**PARK CITY PLANNING DEPARTMENT ADMINISTRATIVE PUBLIC HEARING MEETING
SUMMIT COUNTY, UTAH
May 25, 2023**

925 Woodside Avenue - Administrative Conditional Use Permit - The Applicant Requests Approval For One Retaining Wall Constructed Greater Than Four Feet In Height In the Front Setback. PL-23-05642
(A) Public Hearing; (B) Action
[925 Woodside Avenue Staff Report](#)
[Exhibit A: Draft Final Action Letter](#)
[Exhibit B: 925 Woodside Avenue 2021 HDDR Staff Report](#)
[Exhibit C: 925 Woodside Avenue 2021 HDDR Final Action Letter](#)
[Exhibit D: 925 Woodside Avenue ACUP Final Action Letter](#)

Subject: 925 Woodside Avenue
Application: PL-23-05642
Author: Lillian Zollinger
Date: May 25, 2023
Type of Item: Administrative Conditional Use Permit

Approved renderings

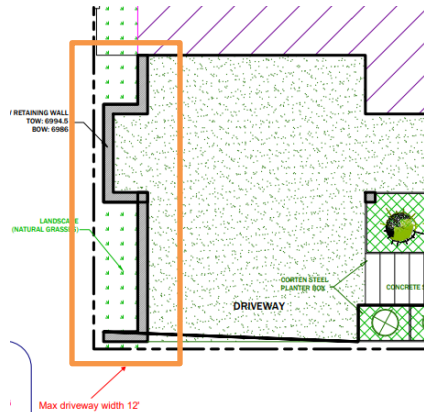
On April 22, 2021, the Planning Department approved a Historic District Design Review (HDDR) to construct a new Single-Family Dwelling at 925 Woodside Avenue (PL-21-04741, Exhibit C and Exhibit D). Per the 2021 Staff Report (see Exhibit C), “the proposal respects existing topography, character-defining site features, and minimizes cut and fill and the use of retaining walls.” The plans approved under the HDDR show a rendering with a cut in the retaining wall in the Front Setback.

The retaining wall was not constructed to the approved plans and is seven feet two inches in height from Final Grade, beginning at the property line, built through the entire ten-foot Front Setback.
